**QUALITY ASSURANCE -- NON-CONFORMANCE REPORT**

**Report No:** NCR-000760

**NCR #:** ZPMC-0722

<b>Welding</b>	<b>Concrete</b>	<b>Other</b>	
<b>Welding</b>	<b>Curing</b>	<b>Procedural</b>	<b>Bridge No:</b> 34-0006
<b>Joint fit-up</b>	<b>Coating</b>	<b>Other</b>	<b>Component:</b> North Shaft Lift 5 Interior Splice Plate
<b>Procedural</b>	<b>Procedural</b>	<b>Description:</b>

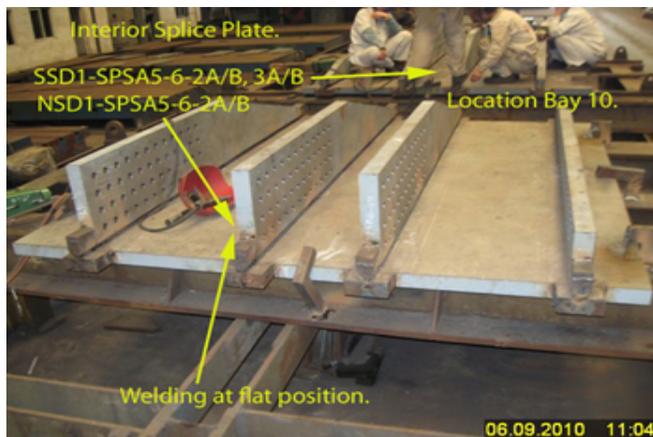
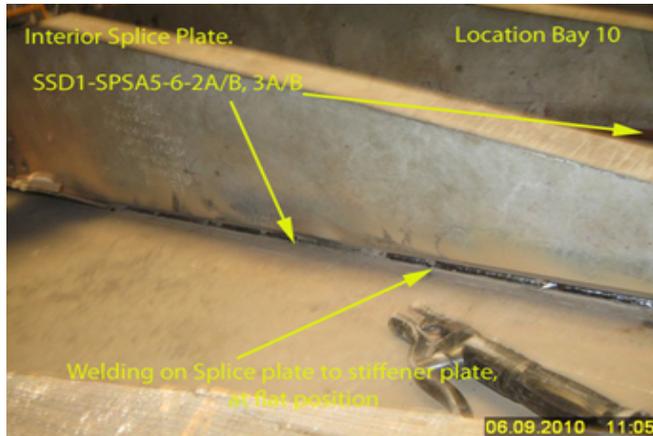
During random visual inspection in Bay 10, this Quality Assurance Inspector discovered the following issues:

- Qualified Welder welding on Interior Splice Plate without following the approved WPS (WPS-B-T-3211-TC-056-1)
- Welding was performed in the 2(G) position, WPS is approved for in the 1(G) position only
- Preheat requirement of 180 Celsius was not performed.
- Approved fabrication procedure was not followed
- Vertical T-jig was not utilized to weld stiffeners in the 1(G) position
- Flat jig was used and welding was performed in the 2(G) position
- The complete joint penetration welds are identified as NSD1-SPSA5-6-2A/B, and SSD1-SPSA5-6-2A/B, 3A/B.
- Interior Splice Plate identified for, North Tower lift 5 skin A, and South Tower lift 5 skin A.
- The member is located in Bay#10.

AWS D1.5 Section 1.9 - All production welding shall be performed in conformance with the provisions of an approved Welding Procedure Specification (WPS)

ZPMC is providing NDT of the welds in question to show they are acceptable. Included is the 2G WPS used to weld the tack welds observed by the Department and the 1G WPS. When compared both WPS have identical welding parameters. In the future the ZPMC foreman will be sure to post relevant WPS so they are visible and can be referred to easily if asked, to address the insufficient preheat ZPMC has in place a refresher training to identify workers who need additional training. Based on these actions, ZPMC requests closure of this NCR.

Here ZPMC clarified as below. On ZPMC's fabrication procedure, it required a vertical T-jig which utilized to weld stiffeners in 1G position. But in order to reduce root pass cracking, ZPMC previously made temporary reinforcement tack weld on the ground which utilized to weld stiffeners in 2G position. Both of these two positions, ZPMC all has the corresponding WPS for utilization.

Contractor provided the NDT report to prove the weld is acceptable. Contractor posted the WPS in a visible place. In addition, training on pre-heat is provided to the workers.
